CY7C129*DV18/CY7C130*DV25
CY7C130*BV18/CY7C130*BV25/CY7C132*BV25
CY7C131*BV18 / CY7C132*BV18/CY7C139*BV18
CY7C191*BV18/CY7C141*AV18 / CY7C142*AV18/
CY7C151*V18 /CY7C152*V18

Errata Revision: *C

RAM9 QDR-I/DDR-I/QDR-II/DDR- II Errata

QDR/DDR DOFF Pin, Output Buffer and JTAG Issues Errata Summary

Figure 1 shows the DOFF pin circuit with an internal 5K Ω internal resistor. The fix planned is to disable the internal 5K Ω leaker.

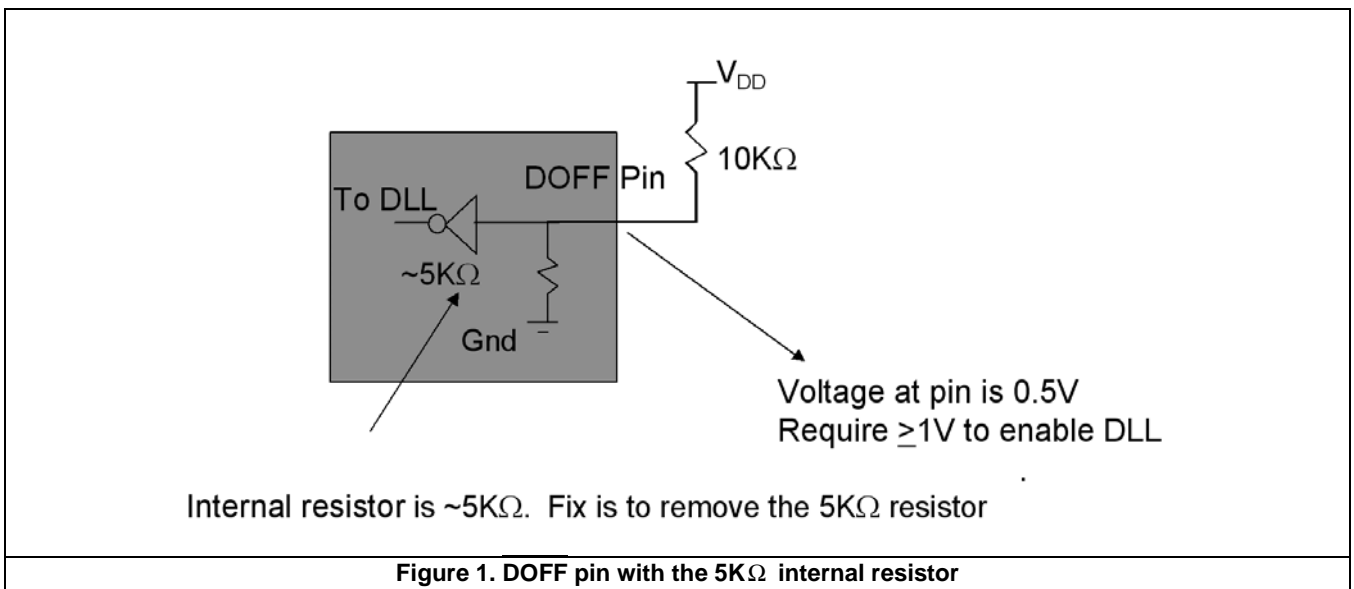
This issue involves the DLL not turning ON properly if a large resistor is used (eg:-10K Ω) as an external pullup resistor to enable the DLL. If a 10K Ω or higher pullup resistor is used externally, the voltage on DOFF is not high enough to enable the DLL.

Fix involved removing the internal pull-down resistor on the $\overline{\text{DOFF}}$ pin. The fix has been implemented on the new revision and is now available. The new revision is an increment of the existing revision. The following table lists the devices affected, current revision and the new revision after the fix.

Figure 2 shows the proposed workaround and the fix planned.

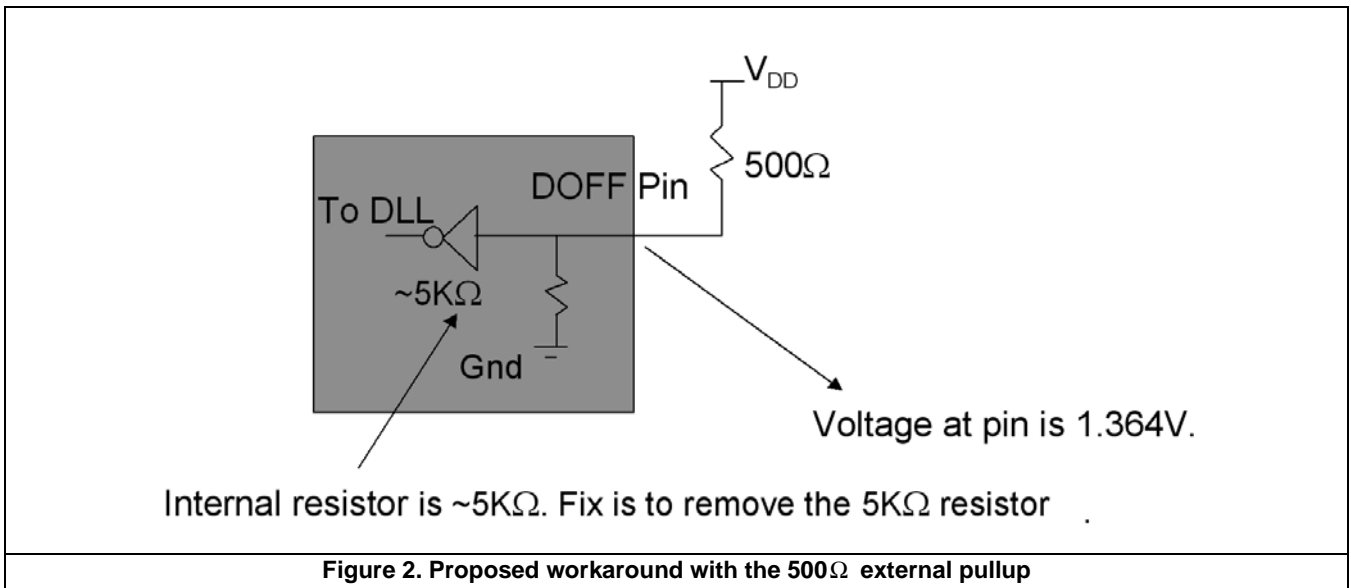
The workaround is to have a low value of external pullup resistor for the $\overline{\text{DOFF}}$ pin (recommended value is $\leq 500\Omega$). When $\overline{\text{DOFF}}$ pins from multiple QDR devices are connected through the same pull-up resistors on the board, it is recommended that this $\overline{\text{DOFF}}$ pin be directly connected to VDD due to the lower effective resistance since the "leakers" are in parallel.

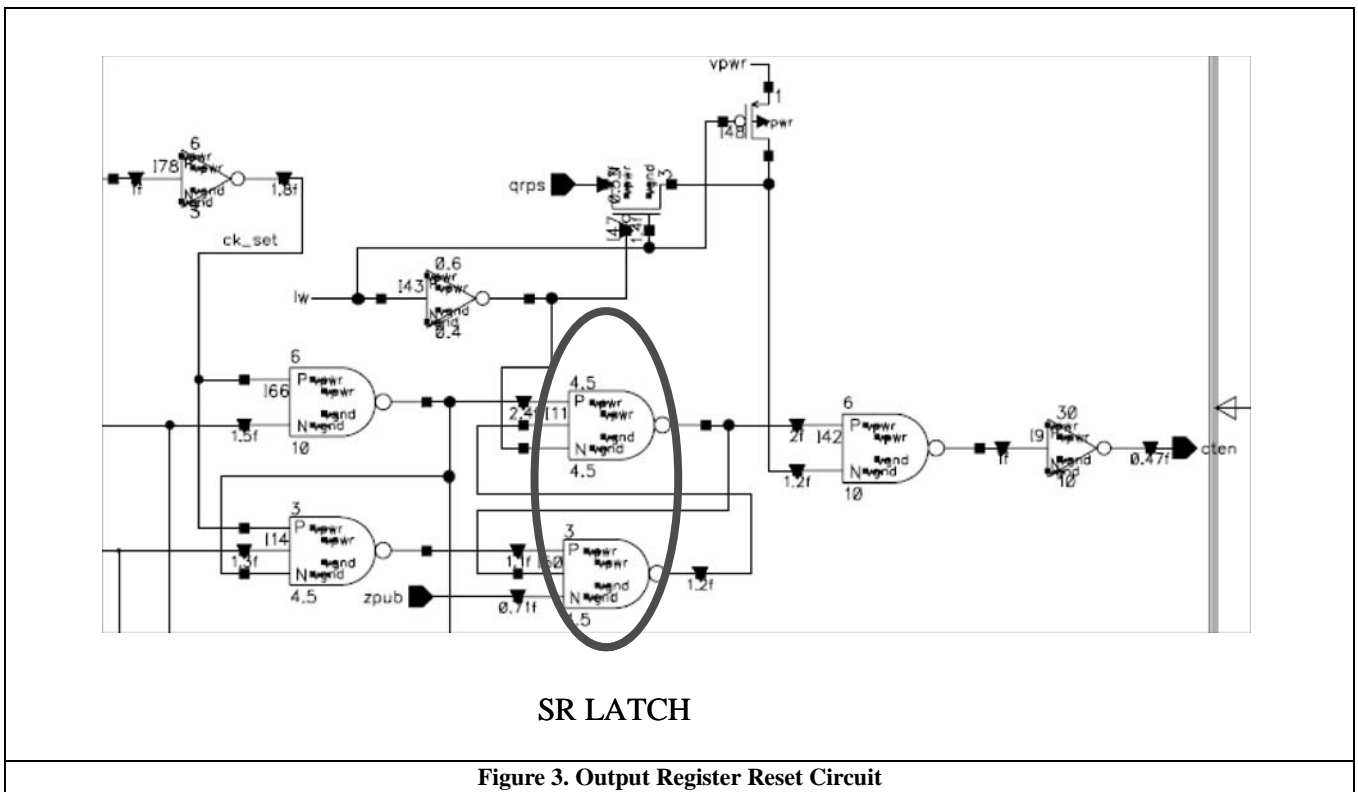
This issue involves the output buffer entering an unidentified state when the input signals (only Control signals or Clocks) are floating during reset or initialization of the memory controller after power up.

Figure 3 shows the output register Reset circuit with an SR Latch circled. This latch has two inputs with one of them coming from some logic affected by the clock and RPS#(QDR) or WE# and LD#(DDR). The issue happens when clocks are glitching/toggling with controls floating. This will cause the SR latch to be taken into an unidentified state. The SR Latch will need to be reset by a dummy read operation if this happens.

The fix has been implemented on the new revision and is now available. The new revision is an increment of the existing revision. Please refer to Table 4 for the list of devices affected, current revision and the new revision after the fix.

Figure 4. Dummy Read Implementation

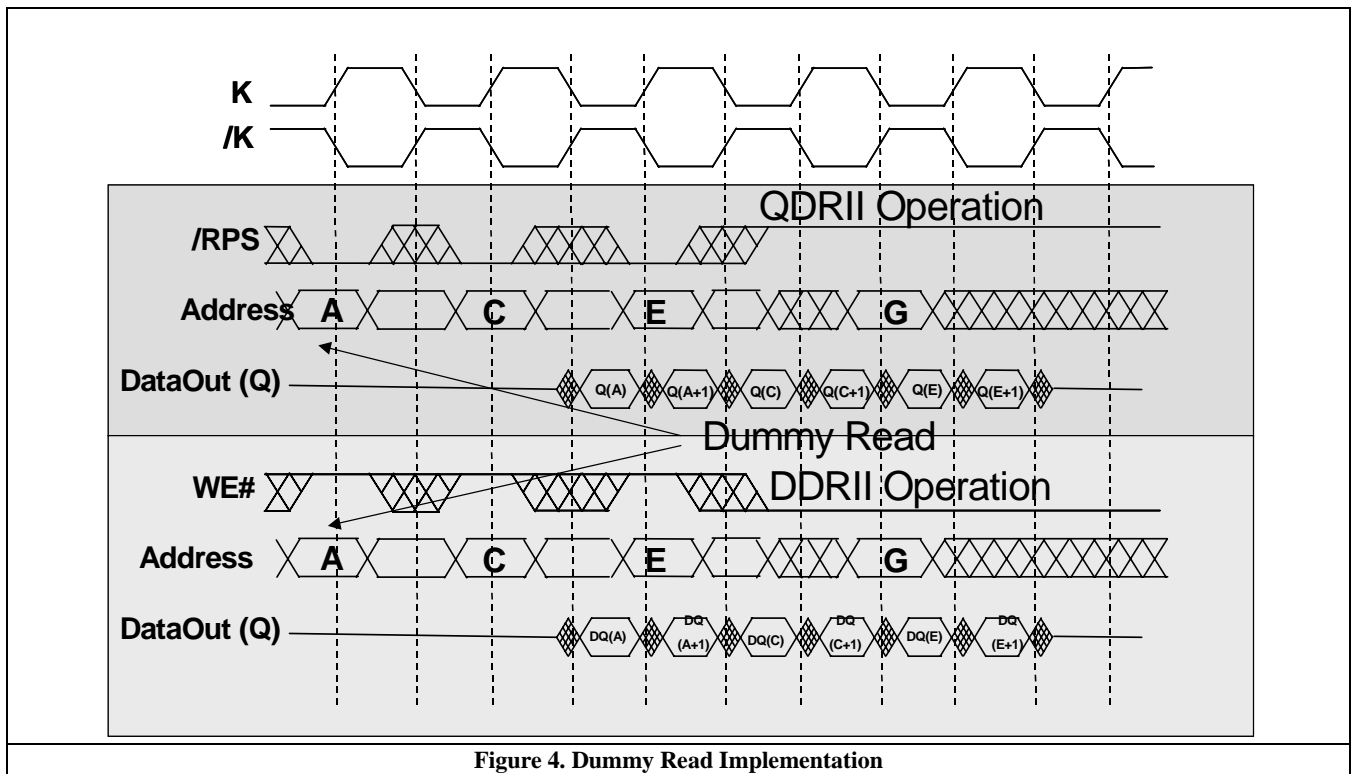
This is viable only if the customer has the trigger conditions met during reset or initialization of the memory controller after power up. In order for the workaround to perform properly, Cypress recommends the insertion of a minimum of 16 “dummy” READ operations to every SRAM device on the board prior to writing any meaningful data into the SRAM. After this one “dummy” READ operation, the device will perform properly. “Dummy” READ is defined as a read operation to the device that is not meant to retrieve required data. The “dummy” READ can be to any address location in the SRAM. Refer to Figure 4 for the dummy read implementation.

In systems where multiple SRAMs with multiple RPS# lines are used, a dummy read operation will have to be performed on every SRAM on the board. Below is an example sequence of events that can be performed before valid access can be performed on the SRAM.

- 1) Initialize the Memory Controller
- 2) Assert RPS# Low for each of the memory devices

For all devices with x9 bus configuration, the following sequence needs to be performed:

- 1) For the 72M / 36M / 18M x9 devices drive address pin A2 / A10 / A3 low respectively and perform dummy read.
- 2) For the 72M / 36M / 18M x9 devices drive address pin A2 / A10 / A3 high respectively and perform dummy read.
